Re: Abengoa Mojave Solar Project (09-AFC-5): Replacement Written Response to Visual Resources Data Request Set 1B, Item 74 and Information Requested by Tom Packard

Visual Resources

Verbal Requests from Tom Packard

AZIMUTH 195

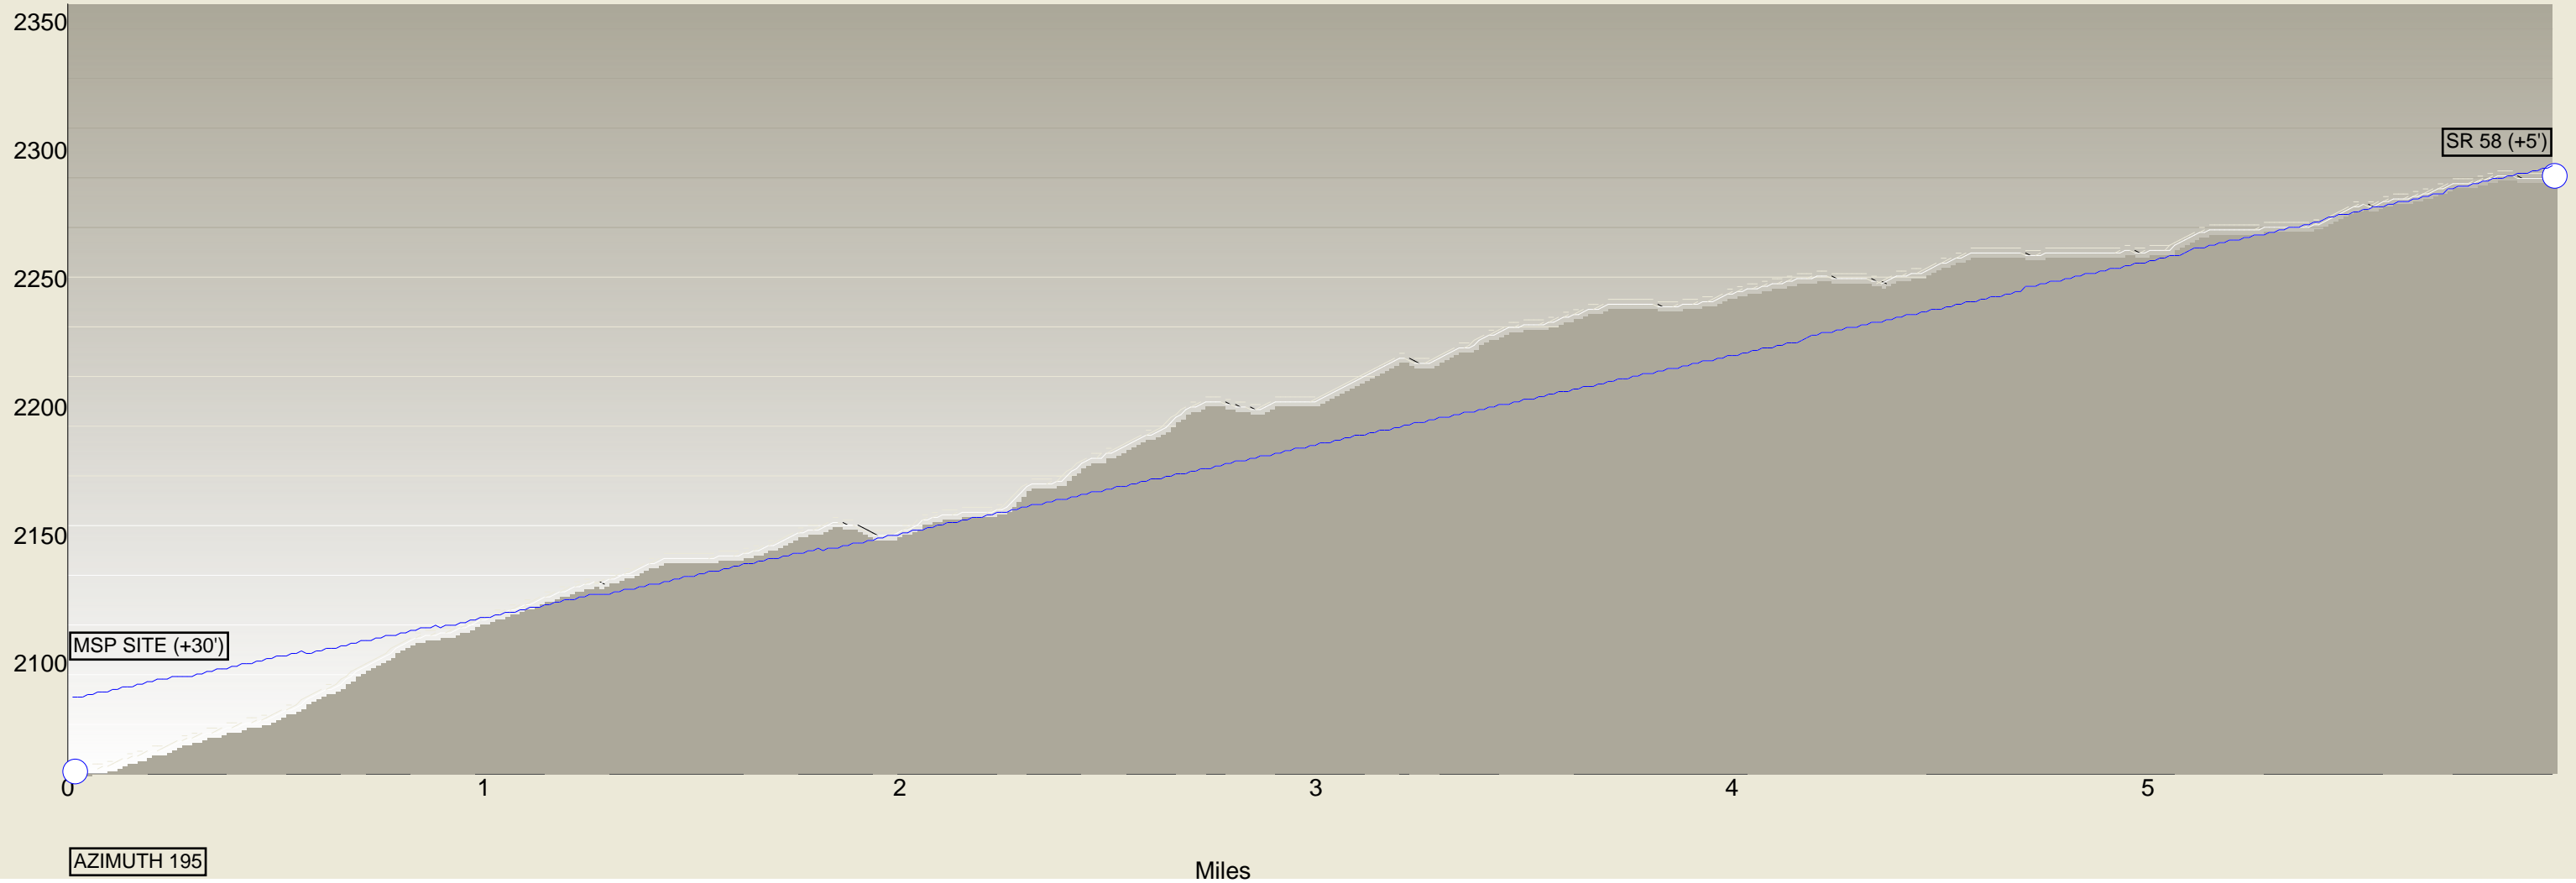
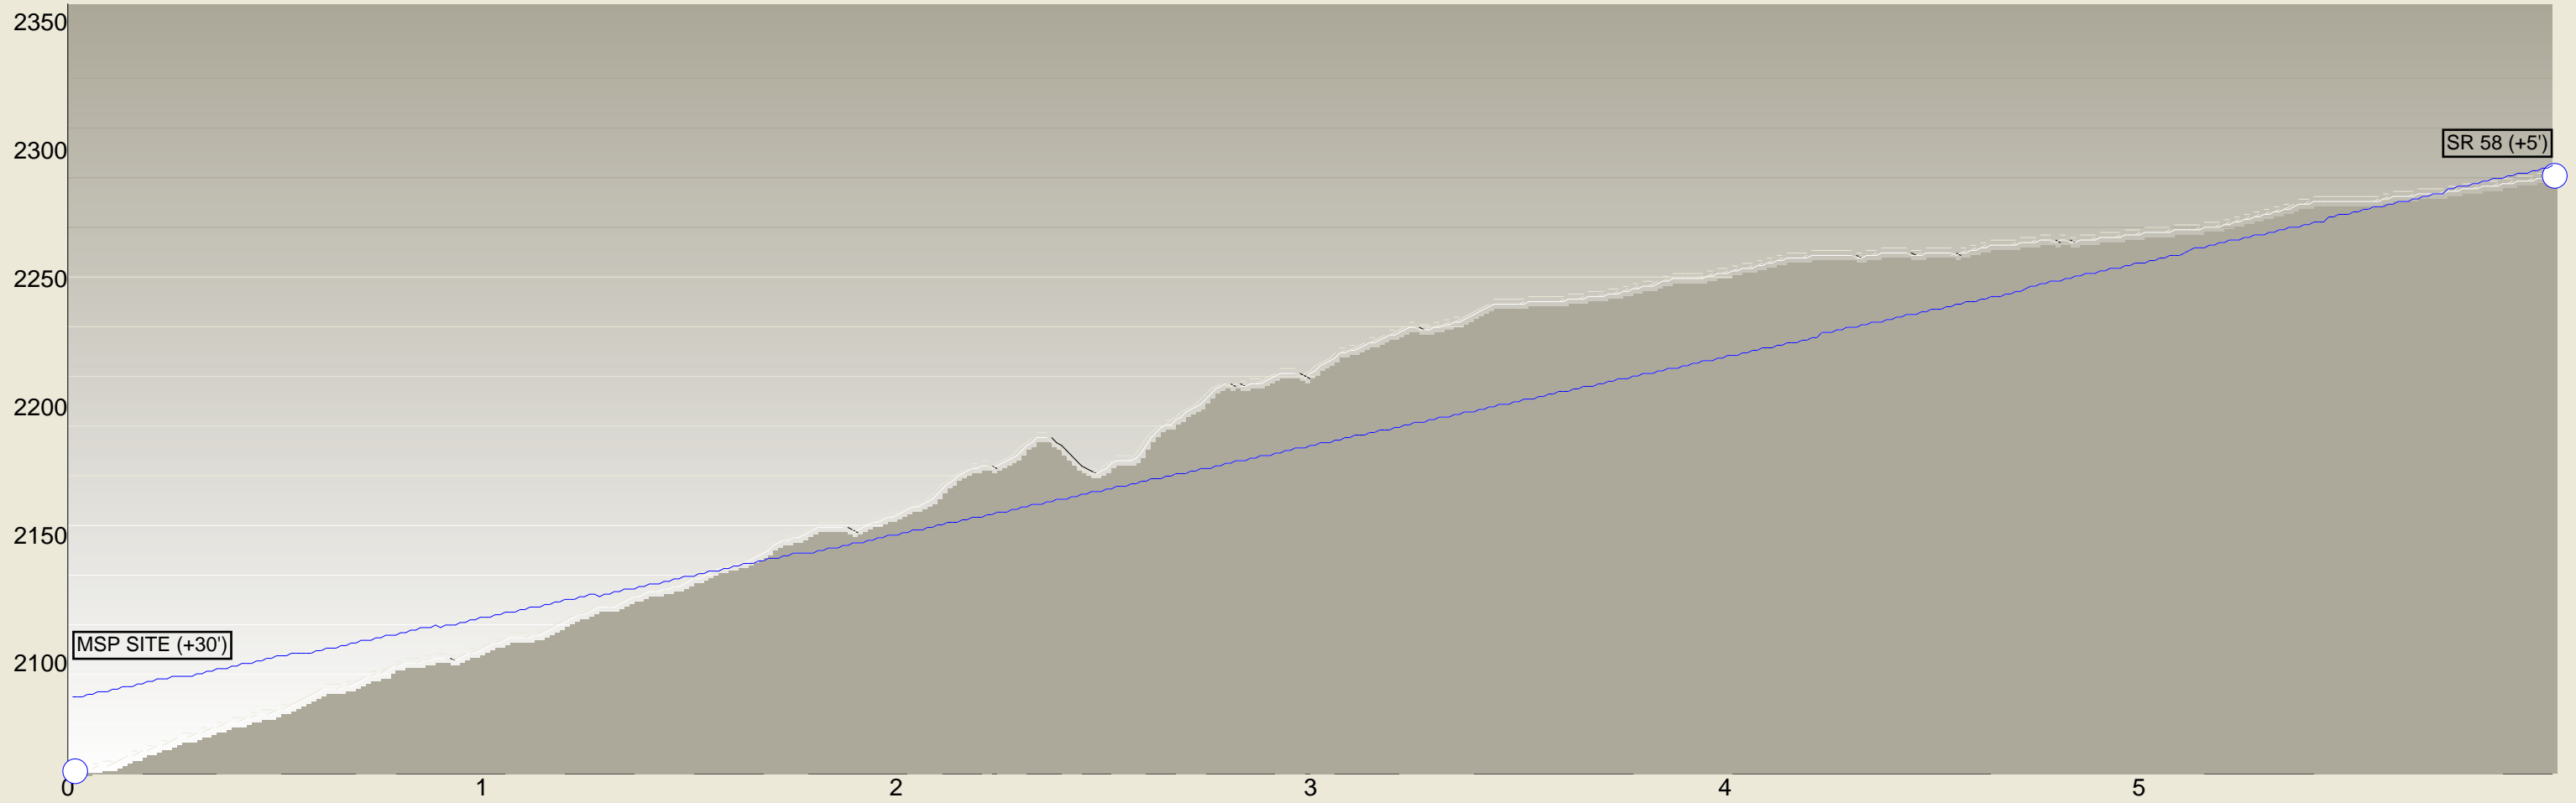
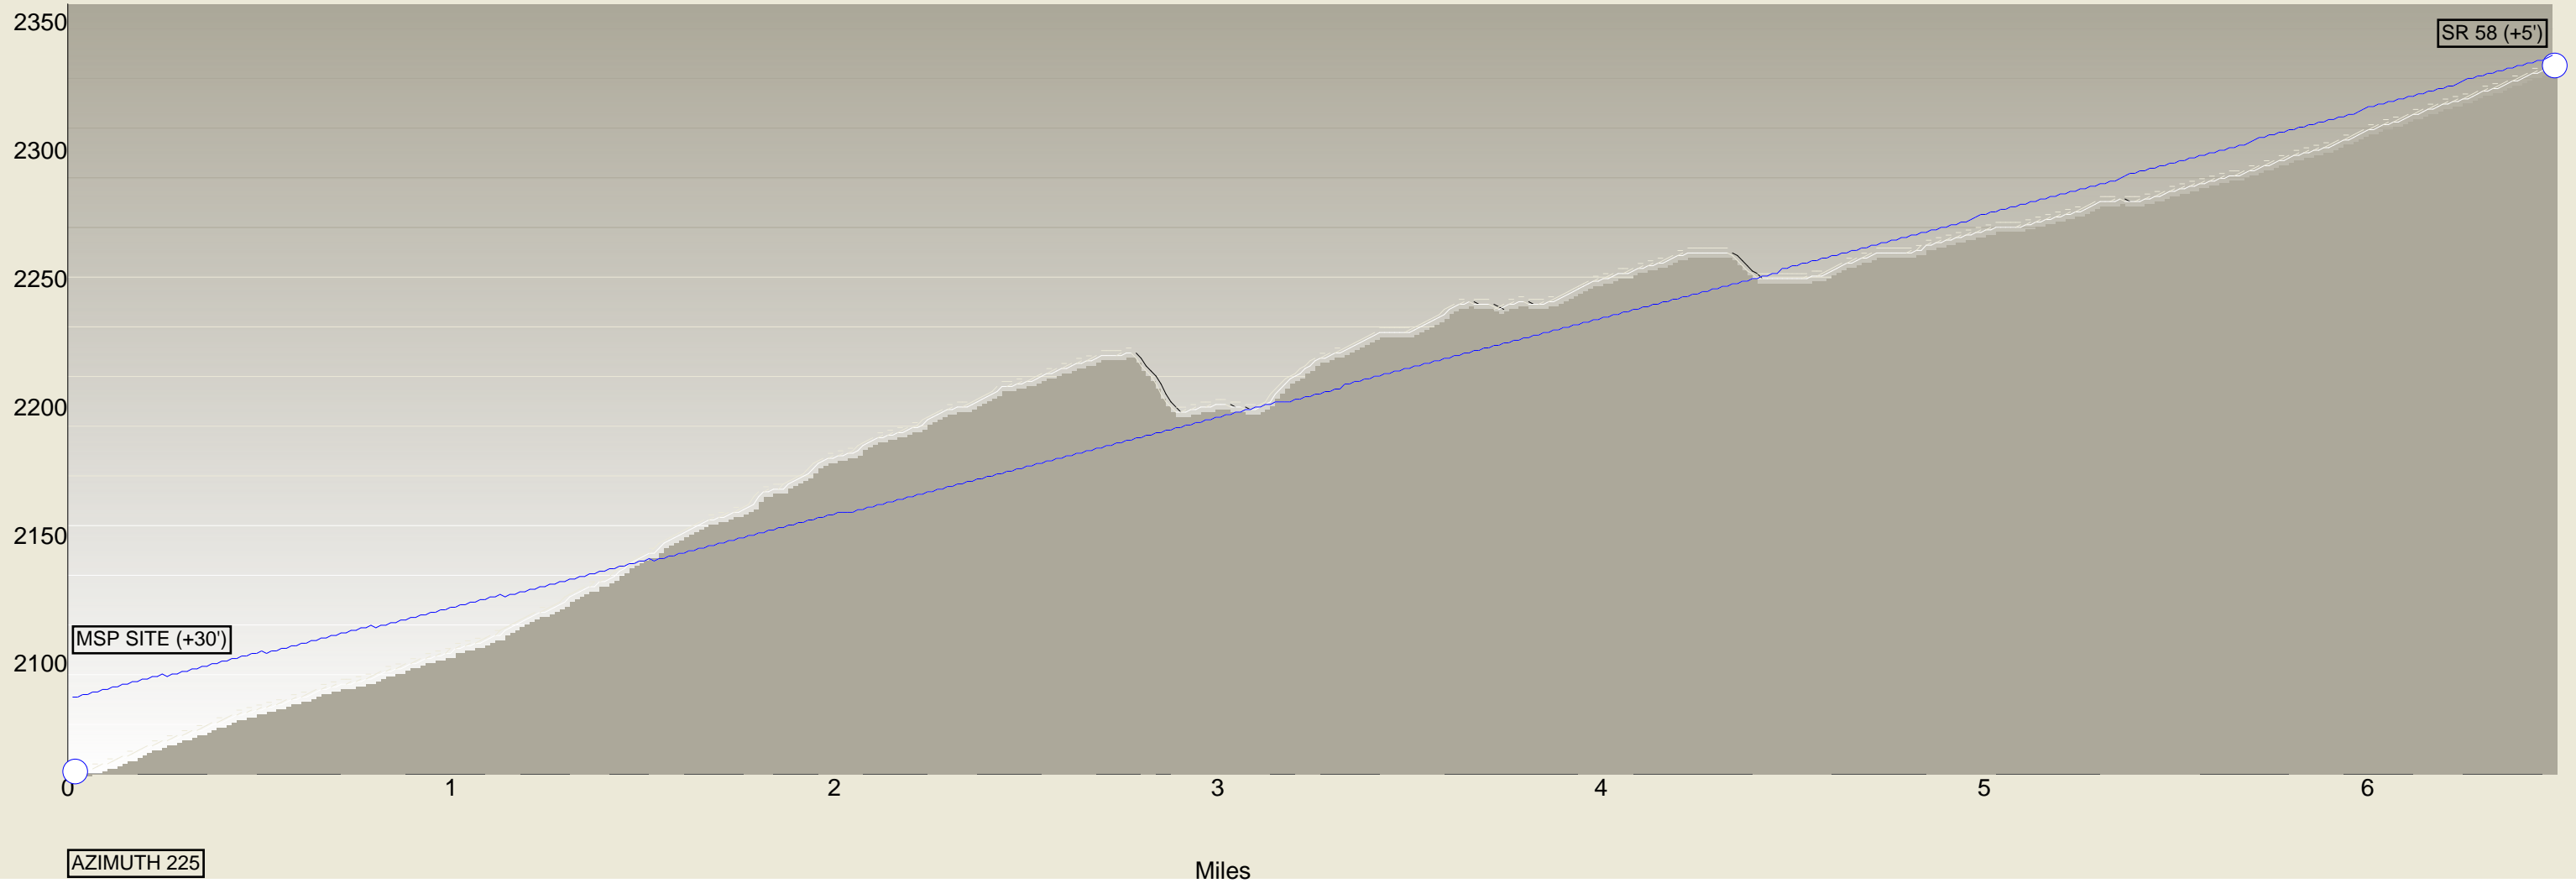
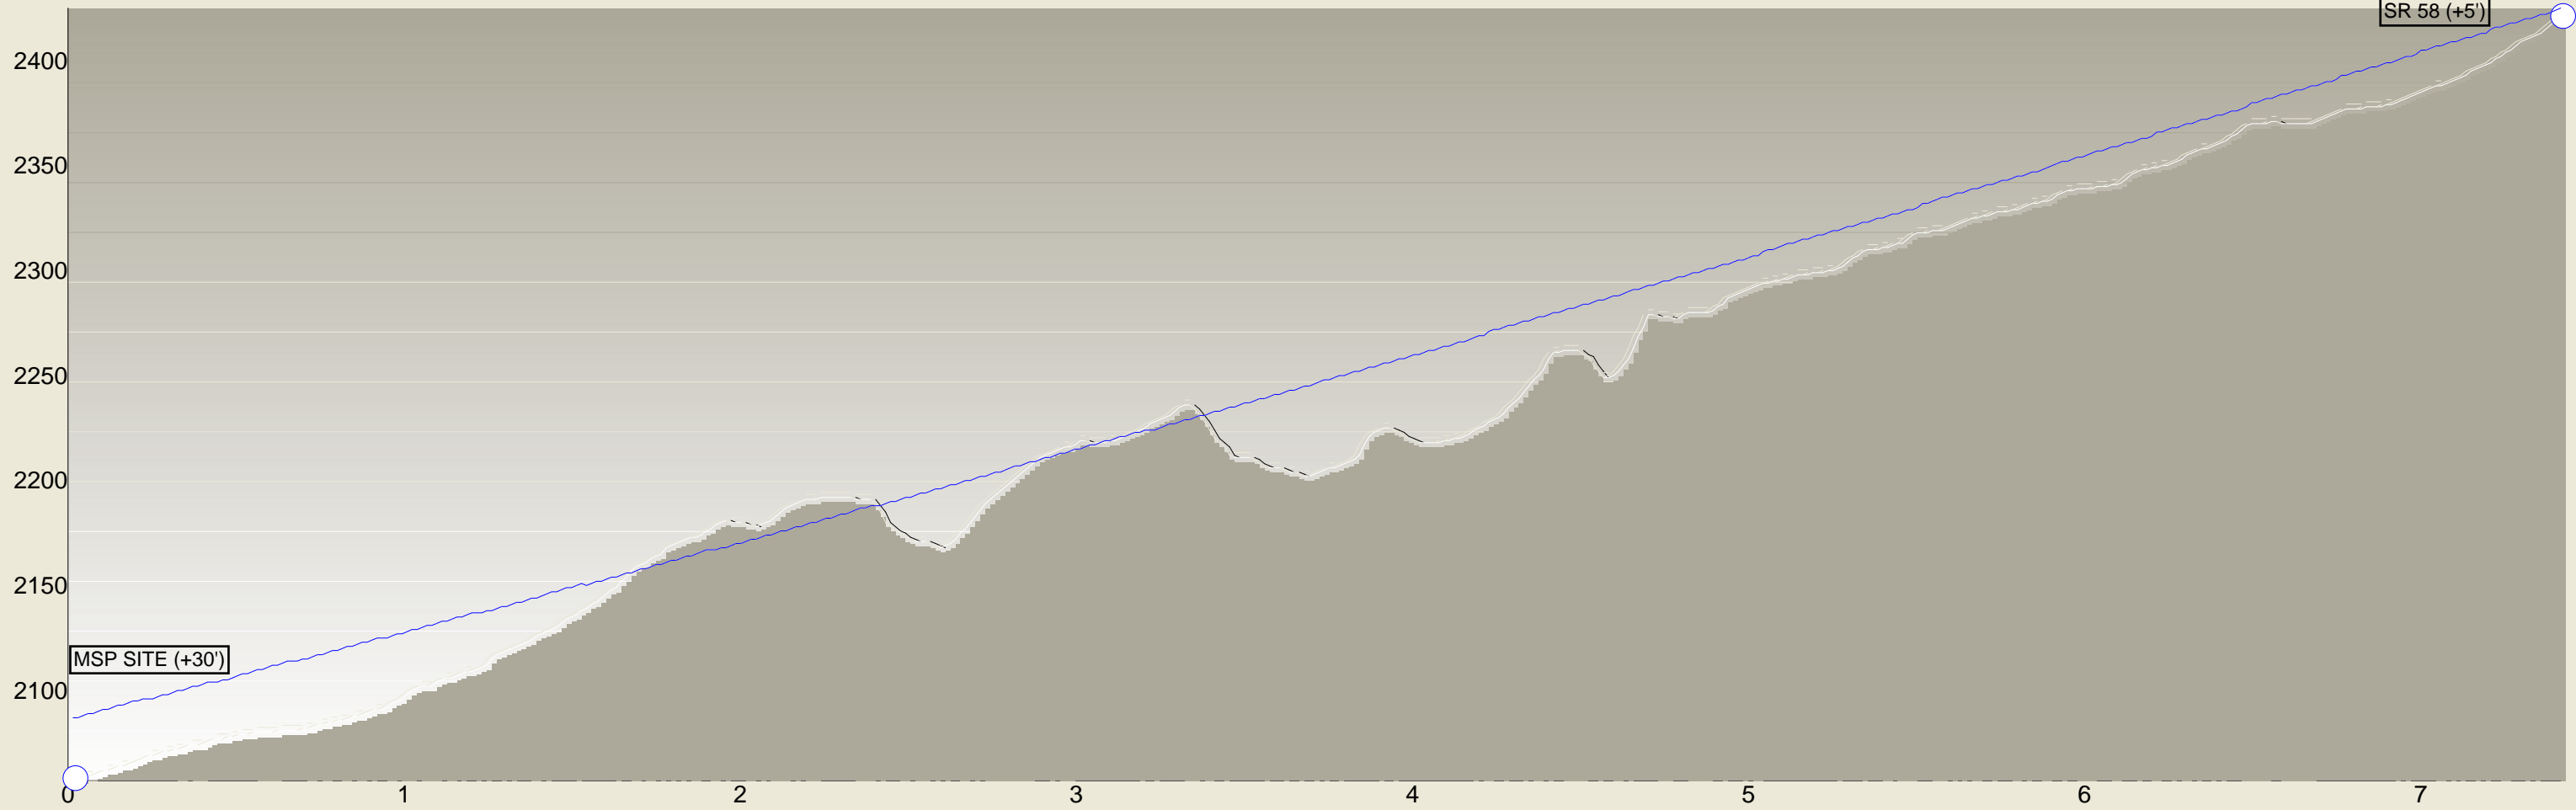
1. Did the visual analysis provided assume a height of finish grade for the analysis? (i.e. did the analysis assume an average height of the equipment?)
2. Did the analysis use USGS mapping?
3. Are there cross-sections available from points along HWY 58 that show the topography obscuring the facility?

1. The analysis used an equipment height of 30 feet above the elevations set for the power islands. This was based upon the mid-point of the tallest structures in the power island area. Then, topography software which is based upon the USGS maps was used to take a cross-section profile at 15 degree azimuth increments around the project site and out to a 15-mile radius.

2. Yes, the software employed is based upon USGS mapping.
3. The following pages contain a base map and cross sections at 15 degree intervals between Highway 58 and the project site. Lines of sight are shown on the cross sections to clarify where topographic visual barriers exist between the highway and the site. The lines-of-sight were set at 30 feet above power island grade at the plant site, as noted previously in response 1, and at 5 feet above road surface on Highway 58 to account for the height of the viewer. Note that the lines-of-sight shown are not straight, but curved to take into account the curvature of the earth over this extended sight distance.
